A1 in Northumberland: Morpeth to Ellingham

Scheme Number: TR010059

6.36 Environmental Statement Addendum: Earthworks Amendments for Change Request

March 2021

M2F-CH135-NB-EBD-4

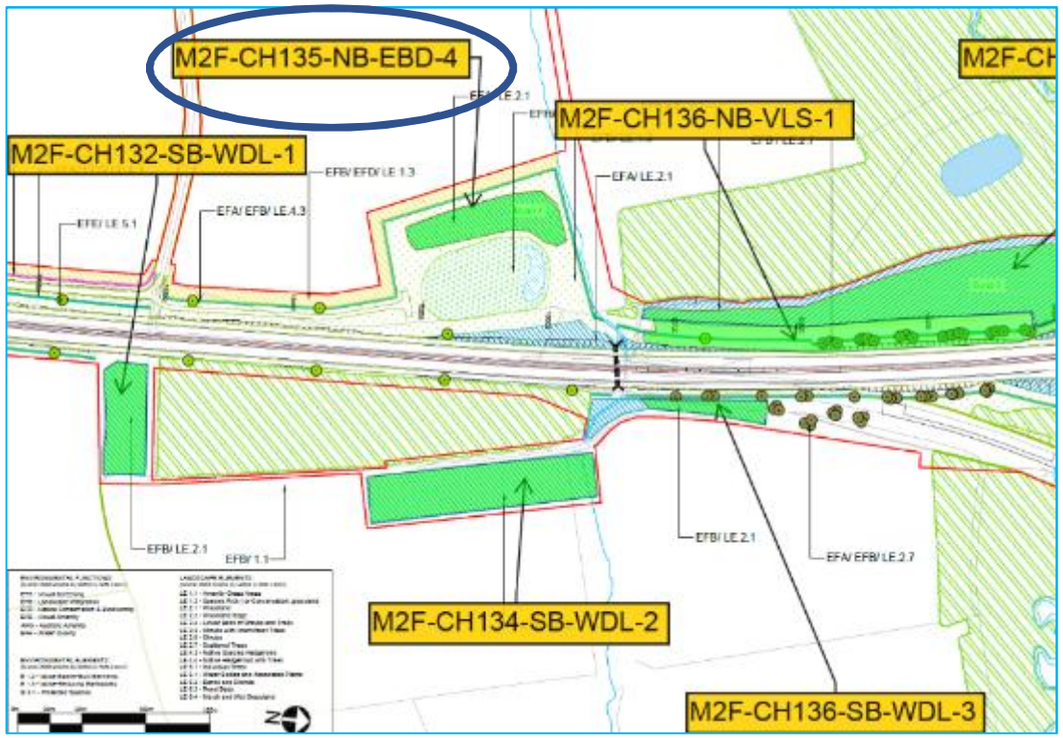
Additional Information:
Proposed soil bund, slackening of slope or disposal of excess site material

M2F-CH171-NB-NGA-1 & 2

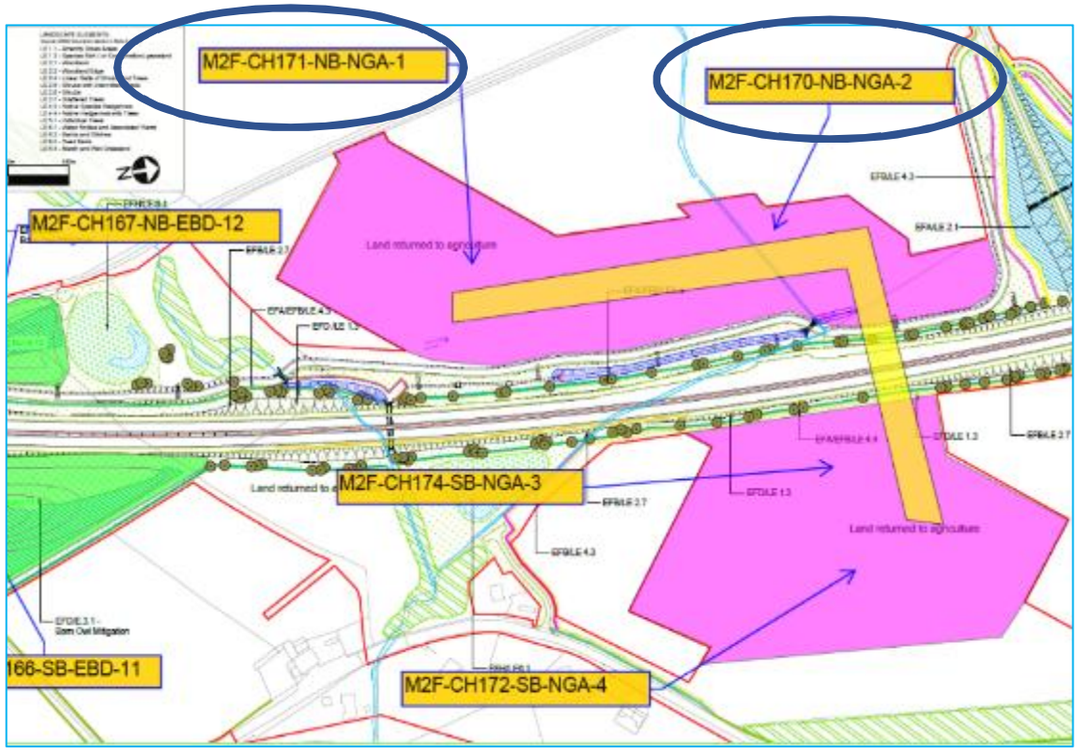
Original designation/function:
Land returned to agriculture

Proposed changes:
- Allow temporary storage/stockpile of soils (in separate mounds), to aid in construction
- Max 2m high stockpiles as per OCEMP

M2F-CH174-SB-NGA-3 & 4

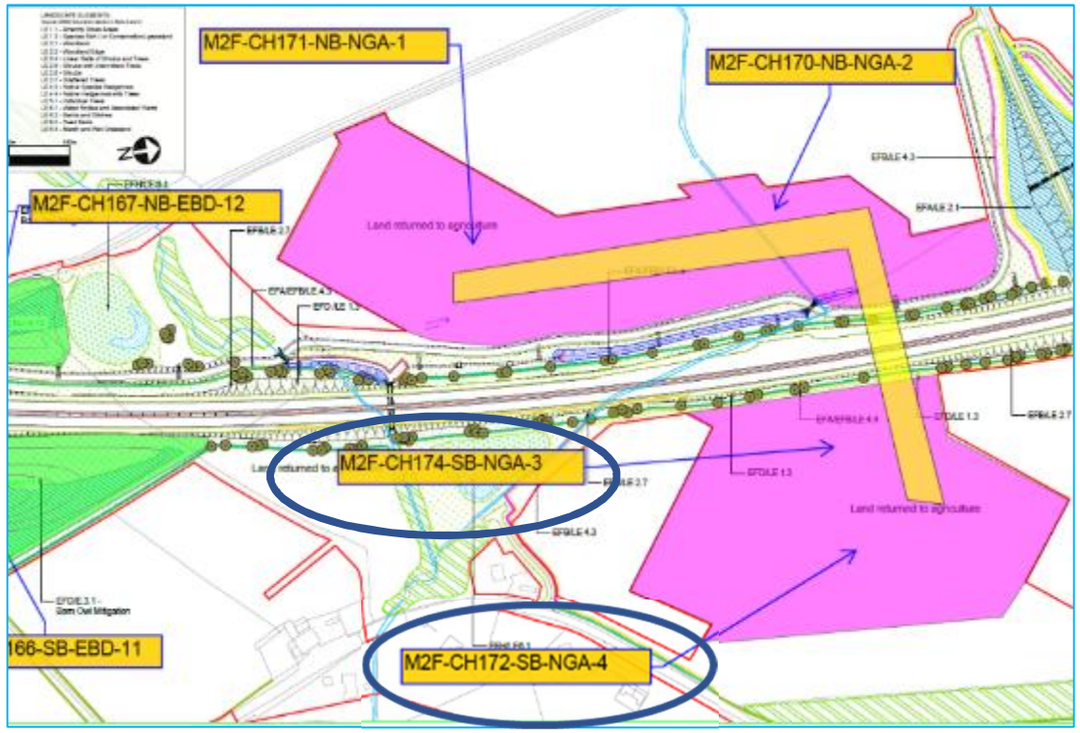
Original designation/function:
Land returned to agriculture

Proposed changes:
- Allow temporary storage/stockpile of soils (in separate mounds), to aid in construction.
- Max 2m high stockpiles as per OCEMP

M2F-CH215-NB-TPS-15

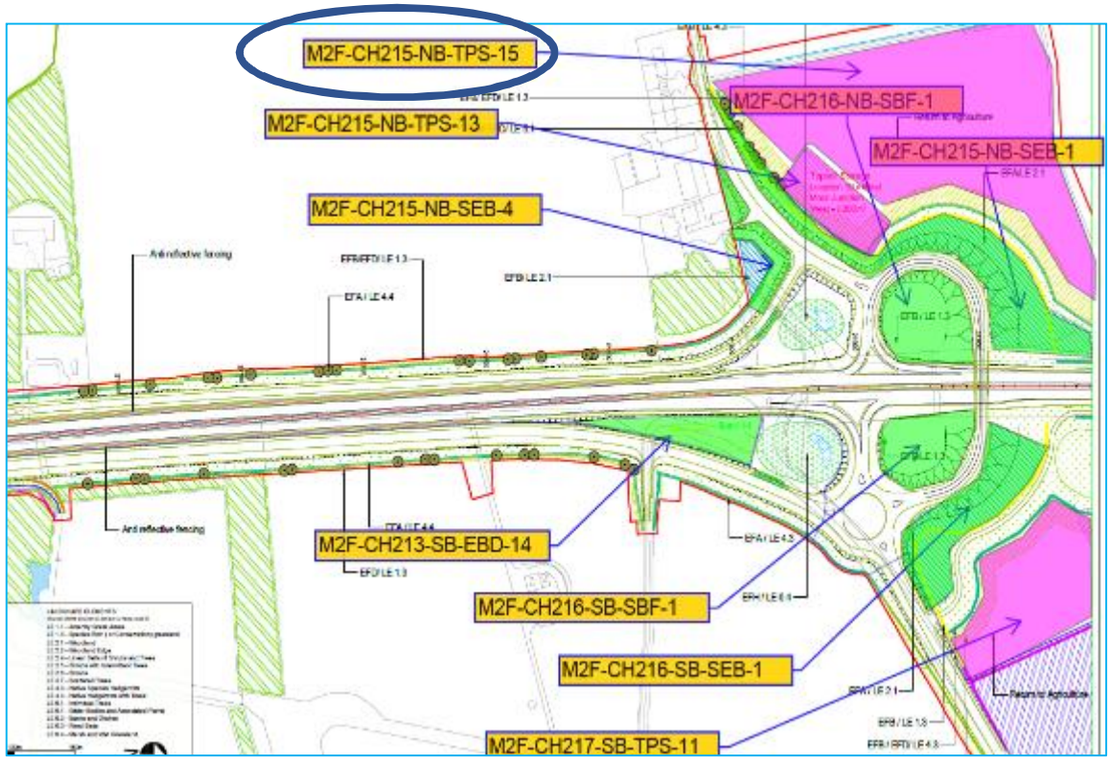
Additional Information:
Return to agriculture

Proposed changes:
- Allow temporary storage/stockpile of soils (in separate mounds), to aid in construction.
- Max 2m high stockpiles as per OCEMP

M2F-CH217-SB-TPS-11

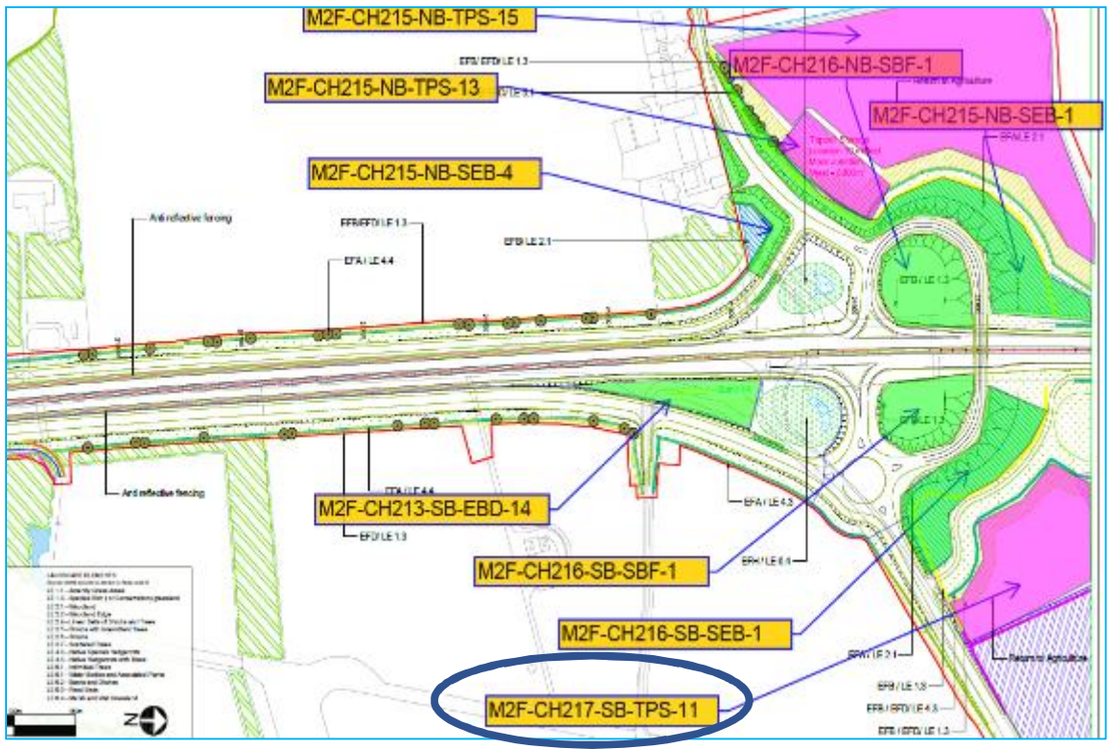
Additional Information:
Return to agriculture

Proposed changes:
- Allow temporary storage/stockpile of soils (in separate mounds), to aid in construction.
- Max 2m high stockpiles as per OCEMP

A2E-CH586-SB-BPT-1

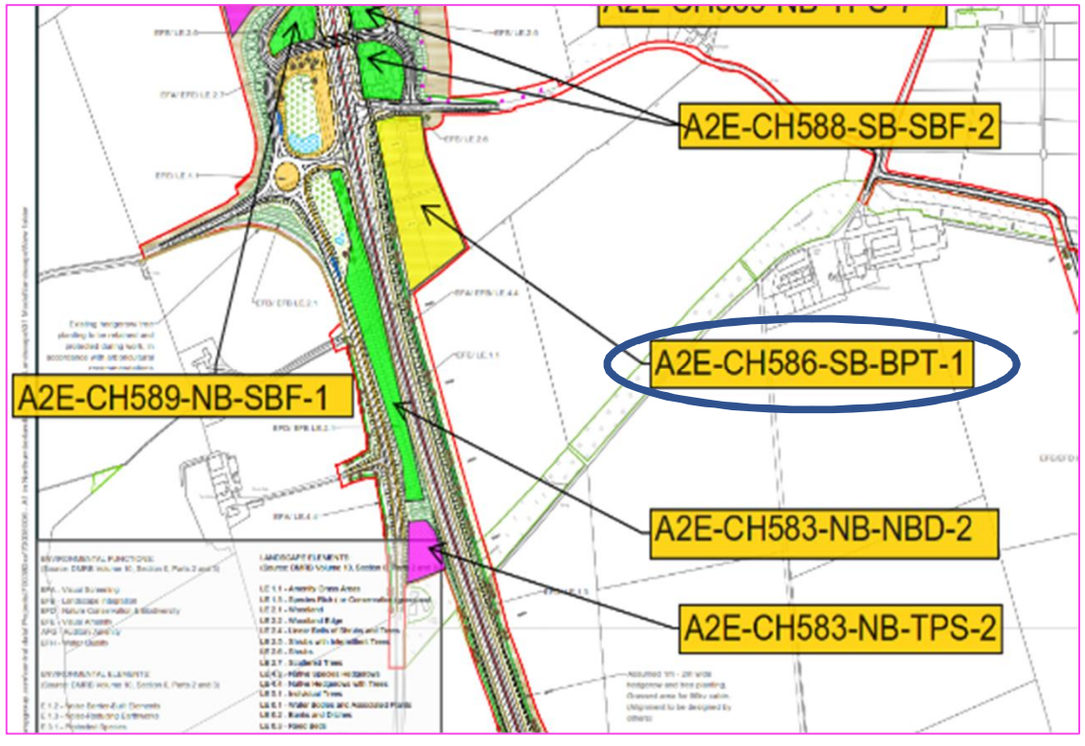
Additional Information:
Return to agriculture

Proposed changes:
- Borrow in fields within essential license.
- Refill to existing ground level with U/S. (Return to agriculture)
- Max depth 5m
